**IGEM/UP/10 Edition 4
COMMUNICATION 1774
2014**

The following Amendments (March 2016) apply to all copies of IGEM/UP/10 Edition 4 published in 2014.

**IGEM/UP/10 Edition 4
COMMUNICATION 1774
2014
AND COMMUNICATION 1786
2016**

The following Amendments (February 2017) apply to all copies of IGEM/UP/10 Edition 4 published in 2014 and 2016.

AN EXAMPLE OF A FLUE/CHIMNEY IDENTIFICATION PLATE <<

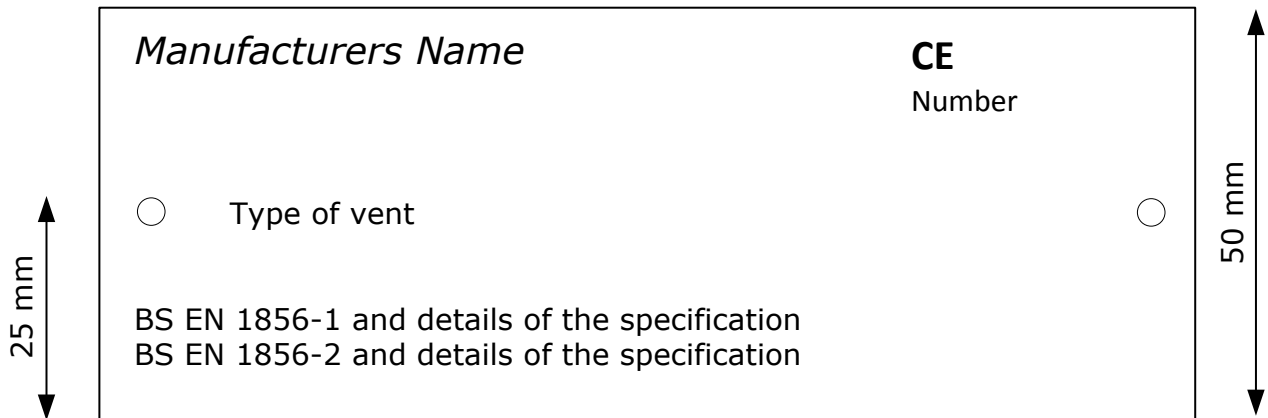
>> APPENDIX 12 : FLUE/CHIMNEY IDENTIFICATION PLATES

In accordance with BS EN 1856-1 chimney identification plates retaining information related to the product specification and are to be permanently secured to a chimney system and/or in close proximity to it in an un-obstructive but visible location. Suitable fixing positions would be either to/or near any clean outdoors, draught stabilisers, manual dampers or boiler connection components. The plate is not to be removed or defaced and in the event the manufacturer/supplier is to be informed so that the appropriate information can be restored to the chimney system.
